UNITED STATES PATENT AND TRADEMARK OFFICE

APPLICATION NO.	FILING DATE	FIRST NAMED INVENTOR	ATTORNEY DOCKET NO.	CONFIRMATION NO.
10/033,163	10/24/2001	Diane M. Landers	DP-304037 / DE3-0203	7139

Office Action Summary

DETAILED ACTION

FIG. 55A

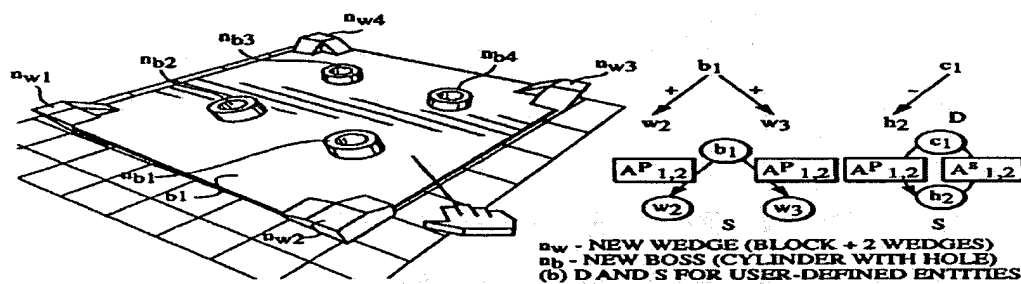
Clearly, the D depicted above, is horizontally structured. The virtual blank is element b1, and a manufacturing feature could clearly be any of nw or nb with exclusive relationships to b1.

Gadh clearly teaches elements as add-ins, wherein, as mentioned above, the figures depict “a machined part constructed in VDSF”. Gadh clearly shows the manufacturing features on a grid coordinate system. Furthermore, Gadh clearly teaches a child element (which can clearly be interpreted, without question, as any of the nw or nb elements) has an associative relationship with the coordinate system. The VDSF display viewed by the user is considered as having a right-left/top-bottom/front-rear coordinate system, whereby the user issues intuitive commands for a user-viewpoint-dependent method of alignment of said child element. And, Gadh also clearly teaches that VDSF determines the XYZ coordinate axes when a viewpoint-dependent alignment command is issued (Col. 24, lines 6-32). Furthermore, Gadh teaches the representation can be implemented in any conventional 2D-CAD systems or VR-CAD systems utilizing VE (Col. 39, lines 33-44). Examiner respectfully submits that “associative relationship” requires no further explanation and that it will be given its plain meaning as required by MPEP 2111.01. Webster's Dictionary defines associative as “of, or relating to, in association with” while relationship as “a state or character of being related...a natural or logical association between two or more things, connection.”
